THORNTON PLACE - PLANNED DEVELOPMENT (PD)

UPDATED ZONING MASTER PLAN

TARA GREENS
ALACHUA COUNTY, FL.

P005

Sheet title:
UPDATED ZONING
MASTER PLAN

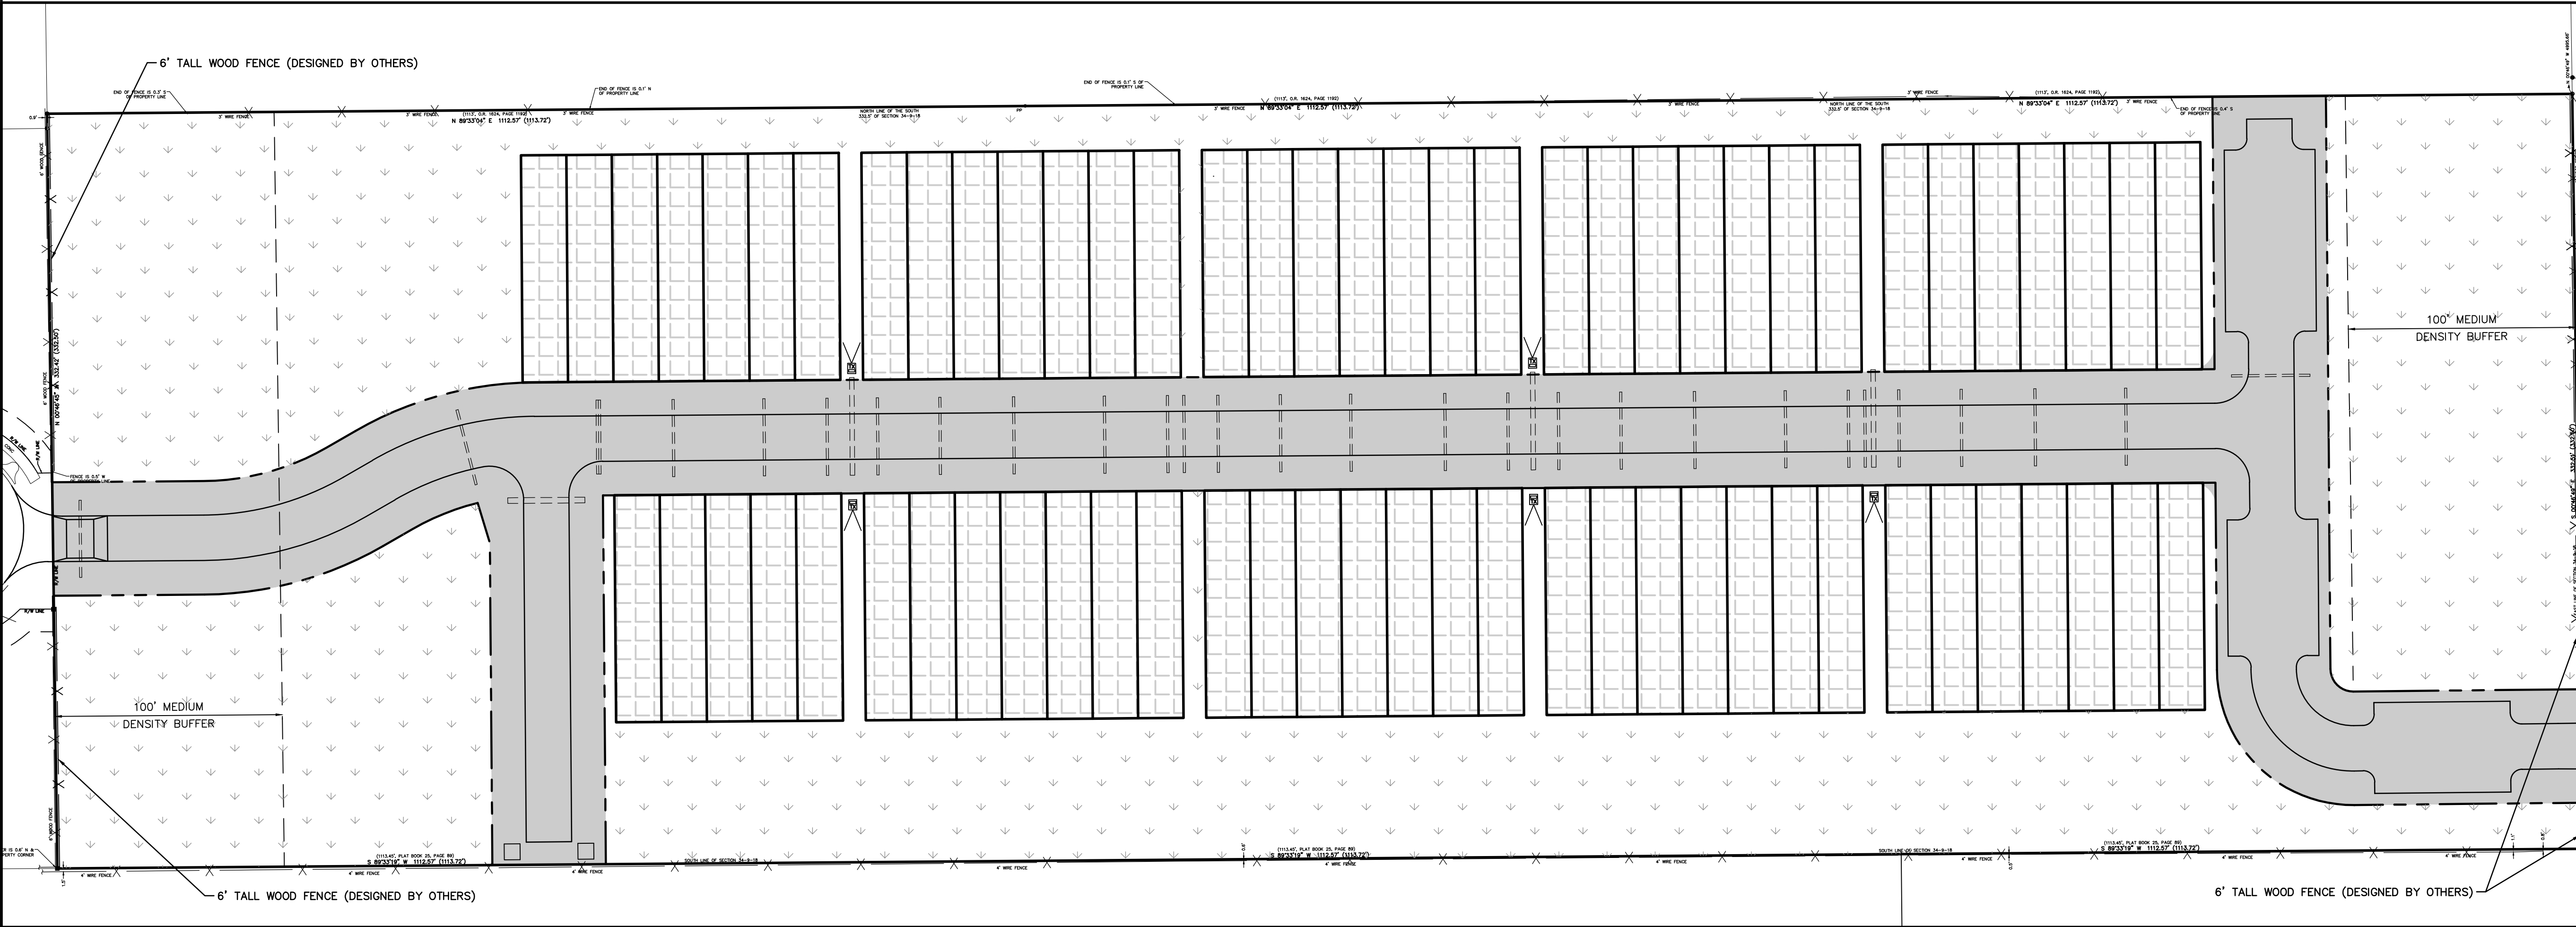
1. THE PLANNED DEVELOPMENT (PD) WILL ALLOW A MAXIMUM OF 68 SINGLE-FAMILY OR MULTI-FAMILY DWELLING UNITS OR A MAXIMUM OF 100 UNITS AS A SENIOR LIVING FACILITY OR ASSISTED LIVING FACILITY, CONSISTENT WITH FLORIDA FAIR HOUSING REQUIREMENTS. CONSISTENT WITH THE RESIDENTIAL MEDIUM-HIGH LAND USE AND R2A ZONING, THE PLANNED DEVELOPMENT ALLOWS A SINGULAR MULTI- FAMILY RESIDENTIAL STRUCTURE, WHICH, IF CONSTRUCTED, THE BUILDING AND ITS ACCOMPANYING STORM WATER FACILITIES AND PARKING WILL BE CENTRALLY LOCATED WITHIN THE SITE SO AS TO PROVIDE BUFFERING TO THE ADJACENT WESTERN AND EASTERN RESIDENTIAL AREAS IN ARBOR GREENS AND STRAWBERRY FIELDS, RESPECTIVELY.

2. ANY DEVELOPMENT SHALL BE REQUIRED TO OBTAIN FINAL DEVELOPMENT PLAN APPROVAL FROM THE ALACHUA COUNTY DEVELOPMENT REVIEW COMMITTEE (DRC) BEFORE DEVELOPMENT TAKES PLACE.

3. PERMITTED USES WILL BE CONSISTENT WITH LAND DEVELOPMENT REGULATIONS (LDR) CHAPTER 404, ARTICLE II. USE TABLE FOR R-2, R- 2A, R-3.

4. THE MULTI-FAMILY DEVELOPMENT WILL MEET REQUIREMENTS OUTLINES IN LDR SEC. 403.10. MULTI-FAMILY RESIDENTIAL REQUIREMENTS WITH THE FOLLOWING EXCEPTION:

THE REQUIRED NUMBER OF PARKING SPACES SHALL BE BASED ON 1.5 PARKING SPACES PER DWELLING UNIT.

5. SIX (6) ADDITIONAL INCHES OF SETBACK SHALL BE REQUIRED FOR EACH FOOT OF BUILDING HEIGHT OVER 35 FEET.

6. EMPLOY DESIGN FEATURES TO ENCOURAGE STRAWBERRY FIELDS AS A SECONDARY ACCESS POINT IN THE SITE PLAN.

RESPONSE: THE DEVELOPMENT PLAN PROPOSES 68 SINGLE FAMILY PLATTED LOTS, WHICH COMPLIES WITH THE DENSITY REQUIREMENT IN THIS CONDITION.

RESPONSE: THE DEVELOPMENT PLAN WILL BE APPROVED BY THE COUNTY PRIOR TO COMMENCEMENT OF ANY SITE DEVELOPMENT/CONSTRUCTION.

RESPONSE: THE PERMITTED USE OF SINGLE FAMILY LOTS IS PERMITTED IN THE R-2, R-2A AND R-3 ZONING DISTRICTS.

RESPONSE: THE PROPOSED PROJECT IS NOT MULTI-FAMILY IN NATURE AND THEREFORE, THIS CONDITION IS NOT APPLICABLE FOR THIS PROPOSED DEVELOPMENT.

RESPONSE: AGREED. ANY BUILDING THAT EXCEEDS 35 FEET IN HEIGHT WILL ADD ADDITIONAL 6 INCHES OF SETBACK, AS NECESSARY.

RESPONSE: DESIGN FEATURES HAVE BEEN INCLUDED IN THE DEVELOPMENT PLAN TO ENCOURAGE STRAWBERRY FIELDS AS A SECONDARY ACCESS POINT, INCLUDING CONSTRUCTION OF A TRAFFIC TABLE ON THE WEST SIDE OF THE PROPERTY, PROPOSED SIGNAGE DIRECTING TRAFFIC EASTWARD AND SHIFTING OF THE NORTH & SOUTH STUB-OUTS EASTWARD AWAY FROM STRAWBERRY FIELDS.
